Discussion

Mr H. C. Adams observed that the Northam Bridge had been constructed on the most up-to-date principles, in spite of the fact that its design had been started 5 or 6 years previously.

FIG. 16.—AERIAL VIEW OF SITE

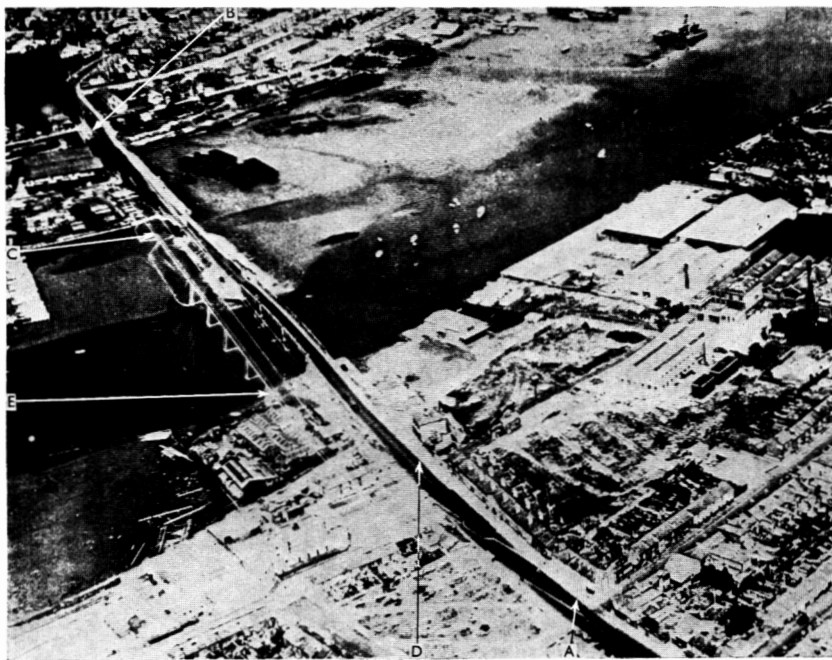
Fig. 16 was a view of the area rather than of the site itself. It showed how close to the old bridge the new bridge had been sited. On the Southampton side, the bridge alignment joined on to the existing road as shown (A). On the north side it carried right through as indicated (B), the whole of the outer stretches being embankment, to a total length of about 2,000 feet. The scour span mentioned in the Paper was shown. Its purpose was to preserve the foreshore levels in the timber pond upstream of the bridge. The embankment over the tidal flats between the scour span and main bridge was also shown. The railway, which had been diverted, originally ran behind the cinema, straight across the road at D and on through the works area. The diverted route was from a point behind the cinema, over the made-up foreshore to the railway span E, and thence *via* a cutting through the old bridge approach.

FIG. 18.—18-INCH GAS MAIN SLUNG IN POSITION

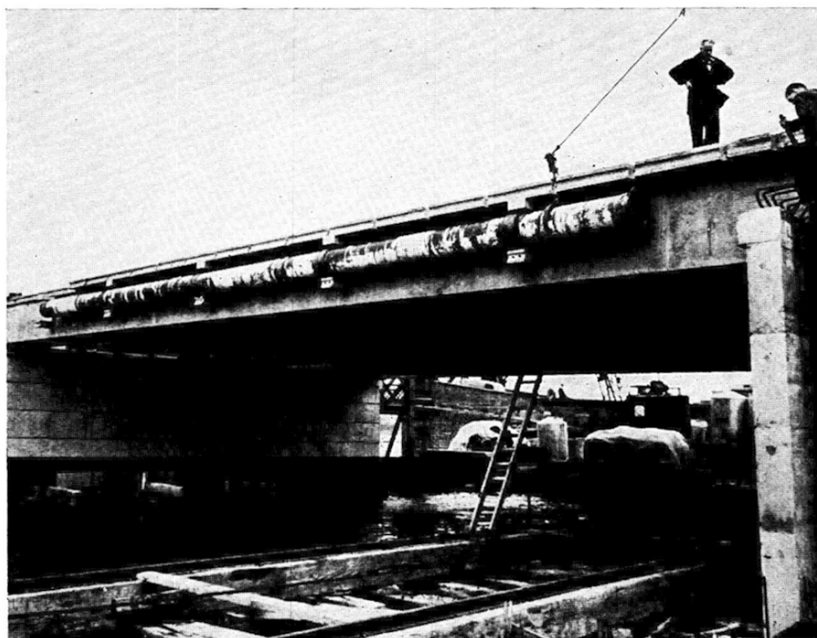
Fig. 18 showed one of the 18-inch gas mains slung over the side of the beam. Each pipe had been slung before the next beam was brought in. The slings consisted of mild-steel straps anchored well back into the deck; one of them could be seen at A. The straps had been so arranged that they remained in position holding the pipe clear of the diaphragms until all the transverse tensioning was completed, leaving just a small amount of concrete to be placed after the removal of the strap.

Mr A. Goldstein asked what would happen in the case of the 18-inch gas main if any replacement were required. His office had recently had occasion to discuss that matter with one of the provincial gas boards, and it appeared that those mains did sometimes leak. From the construction details given in the Paper it looked as if it might be difficult to get a faulty section of the main replaced without dismantling and removing a number of additional sections.

misunderstanding of his opening remarks. Dealing with these and sundry others, he observed that the transference of load from beams to pier was described in the Paper, the end portions of the beams were *embraced* by the diaphragm and keyed thereto; the 2-inch bars had no function in that respect. He had not said that cover-plates should be standardized but that, depending on circumstances, similar devices had become accepted practice; the use of cables or bars had been considered as he had explained. When checked for abnormal loading a small tension was calculable, but he doubted if any would in fact arise. As stated in the Paper, the loss of stress in the steel had been assumed to be 15 tons per square inch (not 15 per cent), observations indicated that 10 tons per square inch would have been ample in the circumstances obtaining. The gas mains could be replaced in a simple manner using a floating stage.

FIG. 19.—AERIAL VIEW OF PARTLY COMPLETED BRIDGE

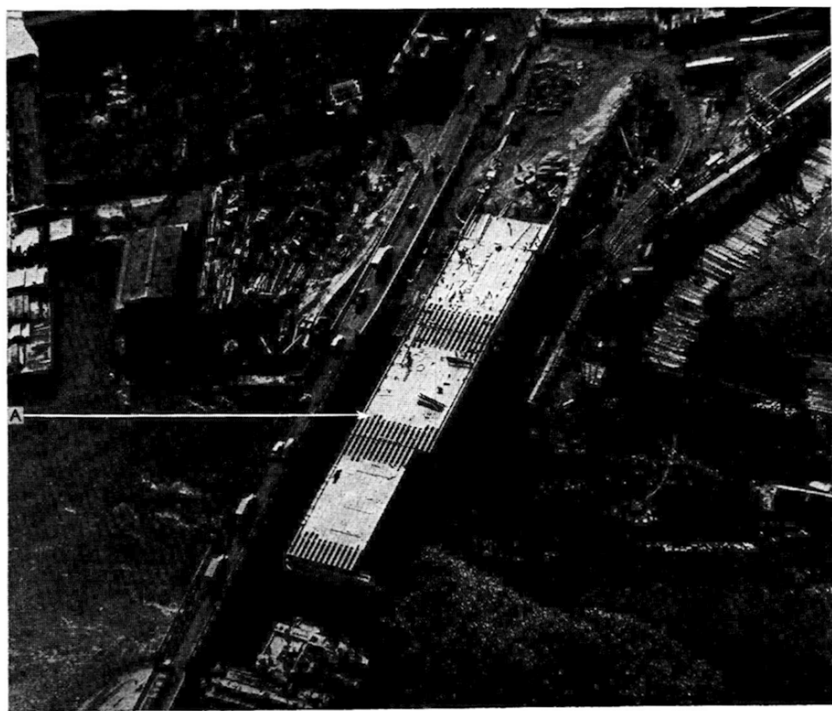
Fig. 19 was an aerial view of the partly completed job. Mention was made in the Paper of the 24-foot width of the old bridge compared with the 65-foot width between parapets of the new bridge. Fig. 19 showed that difference clearly. As a partly-constructed job, there could be seen the gaps where the flanges of the beams were curtailed for the insertion of the continuity slabs over the pier-heads. The longer gaps (A) were to allow the insertion of manholes for access to the services which were laid beneath the deck.
